Broad Oak Farm

Changes to House Type Variants following Client's internal layout changes

Plot 46 – approved

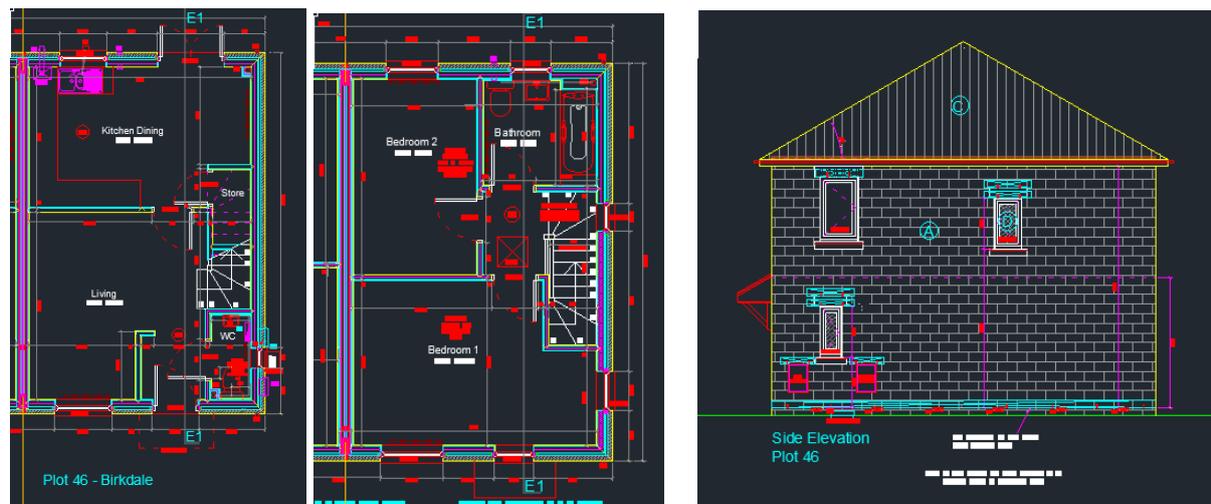
Comments – Revised standard gable elevation for this house type (as approved under NMA) has two windows - GF WC and FF stair. The design originally approved at planning for this plot had five windows in the gable plus one bank window to balance the arrangement, however the internal layout has now changed. The proposed new variant would introduce a further window to the bedroom, however it should be noted that this may compromise the use of the space (wardrobe locations etc). Other planning stage windows have been omitted because the one over the bath would not be appropriate (and as a result any window in kitchen would look odd). Also the window in GF store is not really appropriate.

Plot 47 – approved

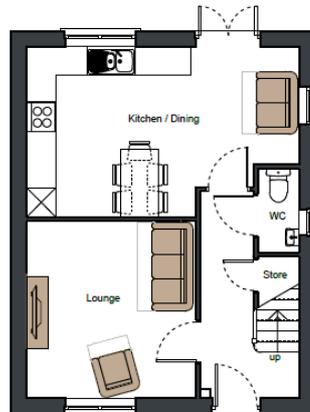
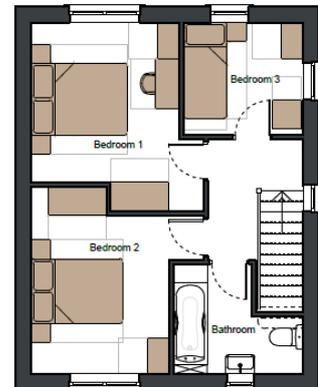
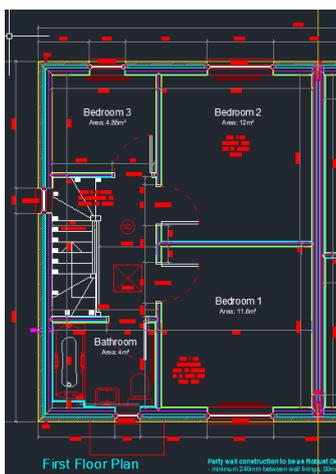
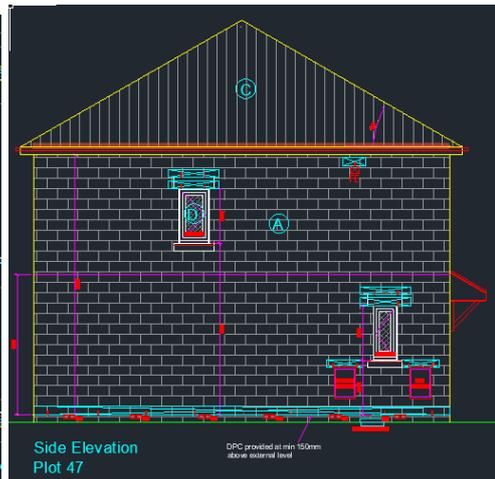
Comments – the gable variant agreed at planning for this plot had four windows in the gable elevation, together with two window blanks. The four windows served the GF WC, kitchen, stair landing and back bedroom. The layout changes agreed by NMA mean that the positions of the WC and landing windows are now offset. It is also no longer possible to provide a window to the kitchen. A window could be provided to the back bedroom, but this may compromise furniture layouts. It would not be appropriate to provide a window over the bath. It is therefore proposed to leave this elevation with just two windows. In this respect it should be noted that the property gives onto a drainage route and that large parts of the side elevation will be concealed by a retaining wall and fence

Plot 92 – approved

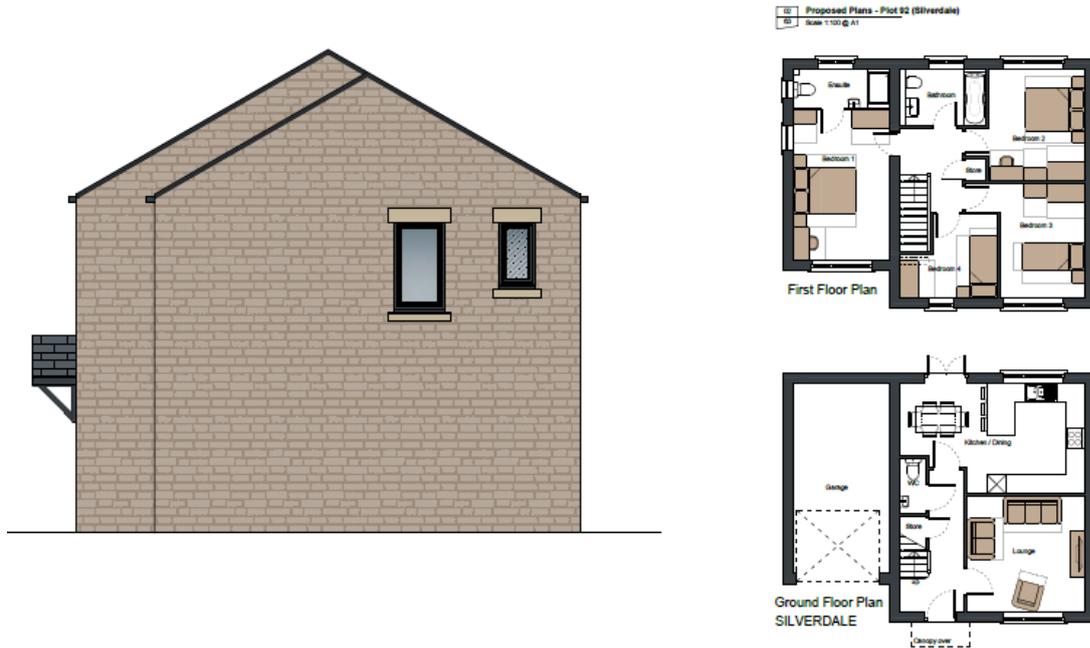
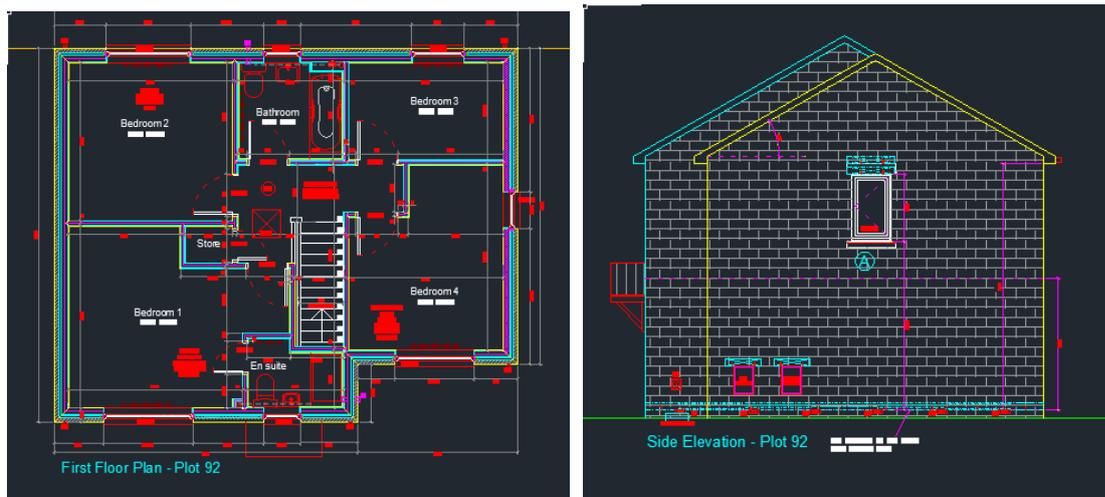
Comments – Standard gable for this house type has no windows. Two gable windows were proposed for this plot at planning (serving a bedroom and en suite). However the internal layout has now changed. It is suggested that the rear bedroom is small and a second window would limit the placement of furniture, therefore it is proposed that this be omitted

Plot 125 – approved

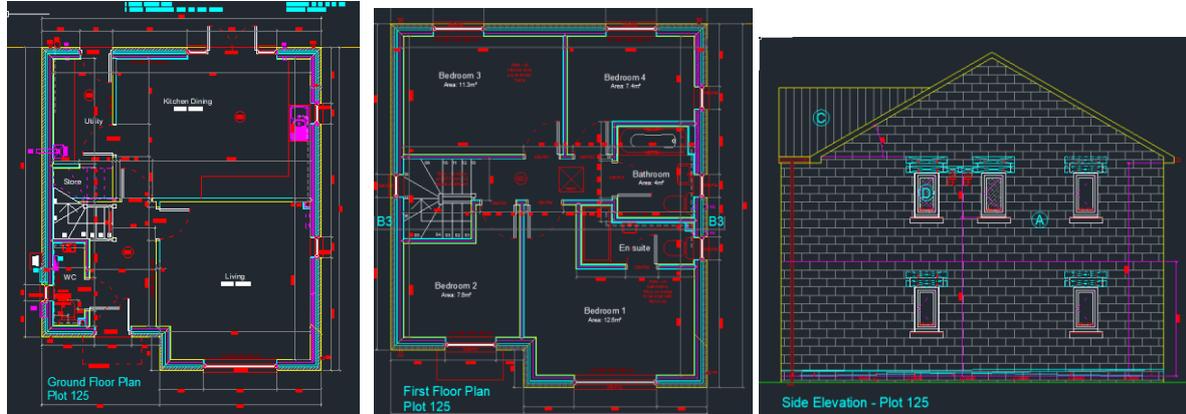
Comments – the standard side elevation for this house type has two first floor windows serving the bathroom and ensuite. The variant originally agreed for this plot introduced three other windows, including a wide kitchen window aligned with the first floor windows above. Changes to the layout have meant that it is no longer possible to align the kitchen window with the upper floor windows (due to clashes with internal walls). Therefore a narrower kitchen window is proposed
